**San Joaquin Solar (08-AFC-12)****Data Request Workshop Action Items Response**

APPLICATION FOR CERTIFICATION  
FOR THE **SAN JOAQUIN SOLAR UNITS 1 AND 2**  
**LICENSING PROJECT**

Docket No. 08-AFC-12

**EXISTING VIEW OF PROJECT T-LINE CROSSING FROM NEW KOP #6  
SAN JOAQUIN SOLAR 1&2**

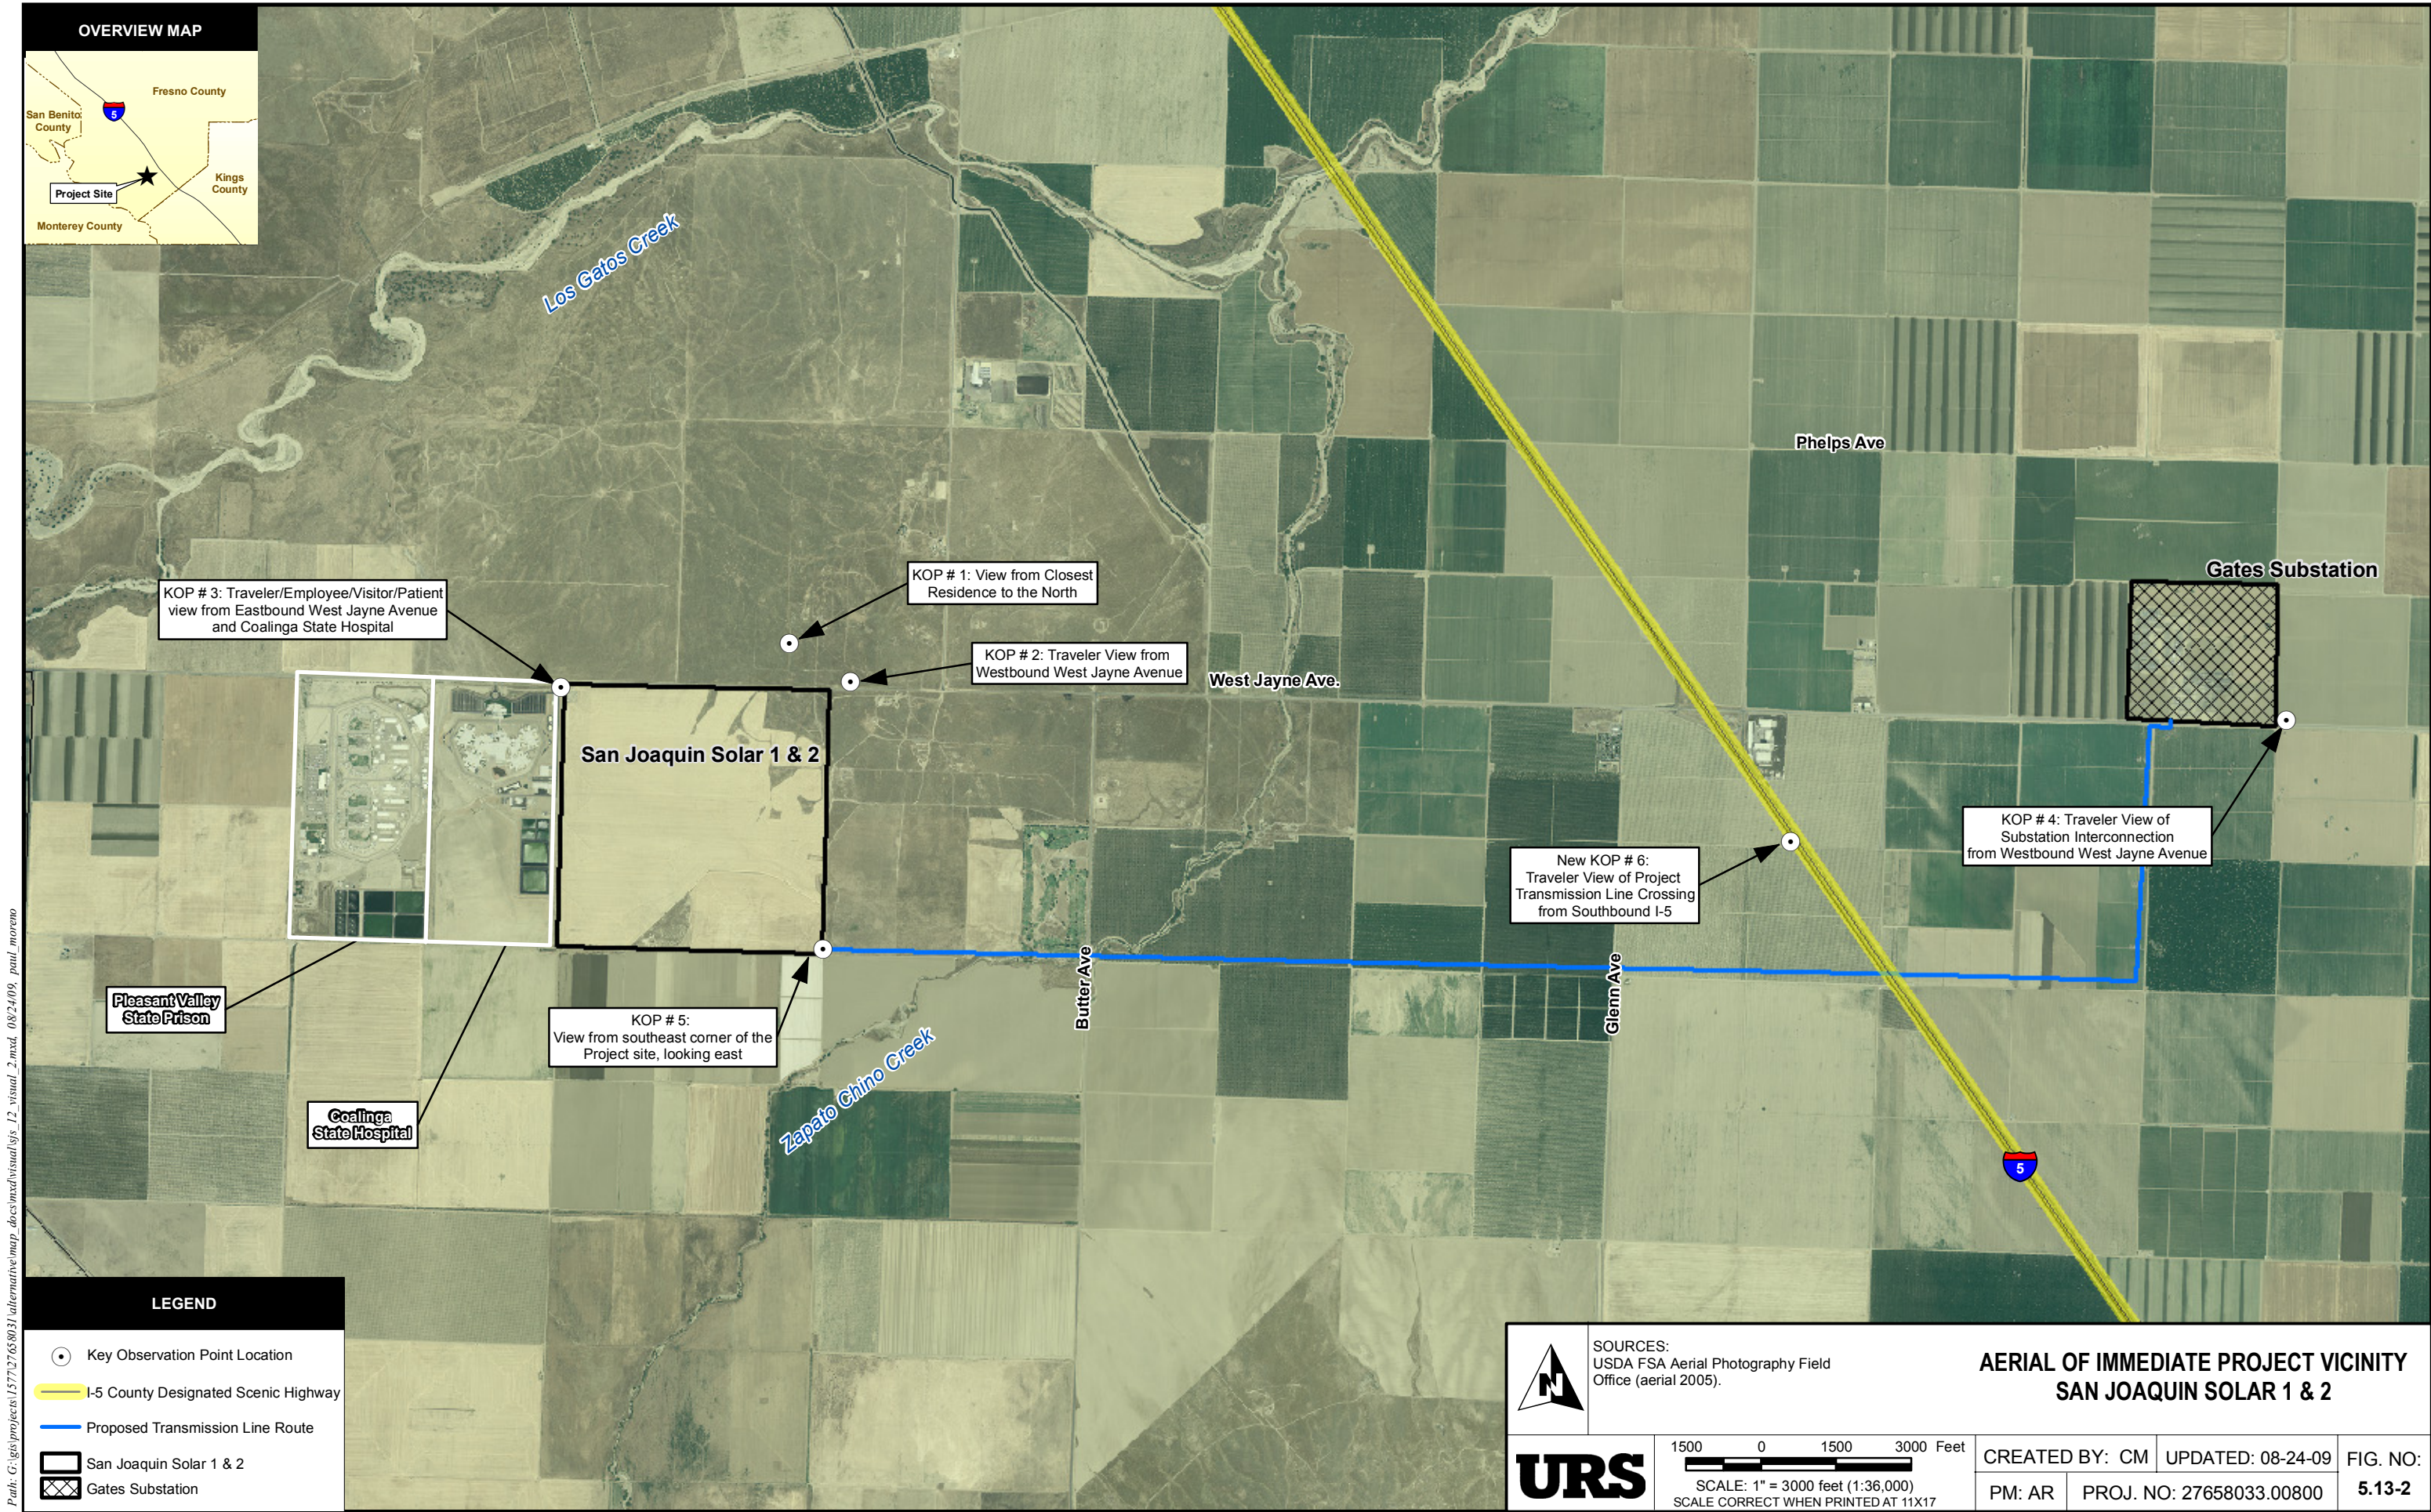
<b>Discipline Area</b>	<b>Action Item</b>	<b>Status</b>
Public health	Coordinate with CARB or SJVAPCD to document evidence of absence of dioxins and furan in ash.	Please see the attached discussion on fly ash dioxins and furans.
Visual	Prepare and analyze a new KOP the southern route transmission line crossing I-5. A new visual simulation will not be necessary.	Please see the attached KOP and analysis.
Visual	Characterize the biomass handling for visual resources.	<b>Complete.</b>
Visual	Identify the purpose of the preserve located north of Jayne Avenue (i.e. public use) for glint/glare consideration.	<b>Complete.</b>
Water Resources	Provide copies of SWPPP, construction SWPPP, and DESP to CEC.	<b>Complete.</b>
Water Resources	Update (with more detail) the existing water use table to include daily max and average water use for operations and construction (including hydrostatic testing etc.).	<b>Complete.</b>

For travelers along I-5, this KOP location (KOP#6) represents the most unobscured view to the proposed overhead transmission line crossing over the I-5. Due to the presence of multiple existing transmission system/networks crossing the I-5 both north and south of the Project's proposed transmission line (see Figure 2) viewer sensitivity to the presence of additional overhead transmission lines is reduced. Also, it is likely that I-5 travelers would be unable to distinguish the presence of an additional transmission line crossing at this location. Further, this view is consistent with short viewing durations (*i.e.*, from travelers focusing on the road). Motorists along I-5 are traveling at a high rate of speed perpendicular to the proposed Project transmission line, which provides for short viewing durations, and reduces visibility and sensitivity. No nighttime lighting is proposed for the transmission line.

Visual impact susceptibility from this location is characterized as low. Visual impact severity from this location is characterized as low. Therefore, aesthetic impact significance from this location is classified as less than significant.

**New KOP 6:** Existing Traveler View of Project Transmission Line Crossing from Southbound I-5 (approximately 3.3 miles east of Project site; and 0.5-mile north of proposed Transmission line Crossing).
